**NAC-MPC CASK SYSTEM**

**NAC INTERNATIONAL  
RESPONSES TO THE

UNITED STATES  
NUCLEAR REGULATORY COMMISSION

FOR REVIEW OF THE NAC-MPC CASK SYSTEM  
(Docket No. 72-1025)  
NAC International**

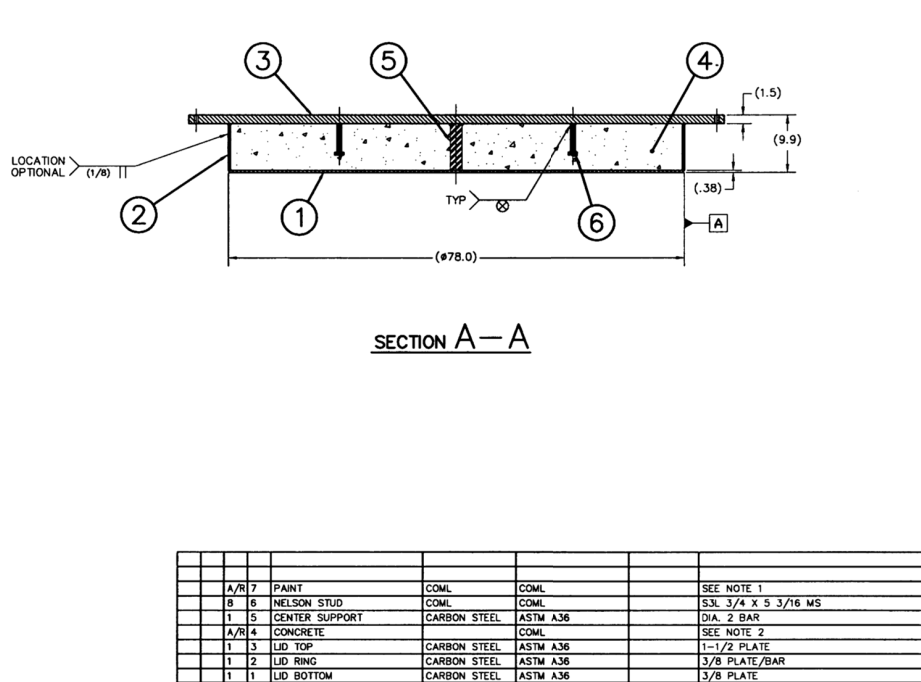
- M-2 Explain whether the concrete in the vertical concrete cask lid is completely encased in carbon steel or is otherwise protected from exposure to the outdoor air and precipitation environment. If the concrete in the vertical concrete cask lid is exposed to the outdoor air and precipitation environment, identify the maintenance criteria or aging management program criteria that are credited toward ensuring that there is no loss of material or deterioration in the material condition of the exposed concrete that could cause a significant increase in radiation dose rates during the approved storage term for CoC No. 1025.

This information is needed to verify either that the concrete in the vertical concrete cask lid is adequately protected from exposure to the outdoor air and precipitation environment, or, if not protected from exposure, that there are suitable maintenance or aging management program criteria in place to ensure that aging degradation of exposed concrete will not lead to material loss or deterioration that could cause a significant increase in radiation dose rates during the approved storage period.

For concrete that is exposed to outdoor air and precipitation, there is potential for intrusion of rainwater and dissolved compounds into the concrete. Based on consideration of the concrete aging mechanisms in NUREG-2214, the staff noted that potential aging mechanisms related to rainwater intrusion for exposed concrete include freeze and thaw, reaction with aggregates, chemical attack, leaching of calcium hydroxide, and salt scaling. Since there is no structural strength requirement for the concrete in the cask lid, the staff noted that the above aging mechanisms are only a concern if they result in significant loss of material or formation voids, cracks, and/or other concrete deterioration that could cause an increase in radiation dose rates.

The concrete in the NAC-MPC LACBWR vertical concrete cask lid is completely encased in carbon steel and thus protected from exposure to the outdoor air and precipitation. The renewal application identified the components (Lid Top, Lid Ring, Lid Bottom and Concrete) of the lid as in-scope because of its function being Structural Integrity (SR), Radiation Shielding (SH), and/or both and their quality category. Additional, aging management reviews of the lid materials determined based on the guidance in NUREG-1927, “Standard Review Plan for Renewal of Specific Licenses and Certificates of Compliance for Dry Storage of Spent Nuclear Fuel” and NUREG-2214, “Managing Aging Processes in Storage (MAPS) Report”, that fully encased concreted did not require aging management. Furthermore, the aging effects requiring management during the period of extended operation are those that could cause a loss of passive SSC and SSC subcomponents intended functions. If the degradation of SSC subcomponents would be insufficient to cause a loss of function, or the relevant conditions do not exist at locations that utilize the NAC-MPC System for the aging effect to occur and propagate, then aging management is not required. An excerpt from the NAC-MAP LACBWR license drawing (630045-863, Lid Assembly, Vertical Concrete Cask (VCC), MPCLACBWR) is provided below.
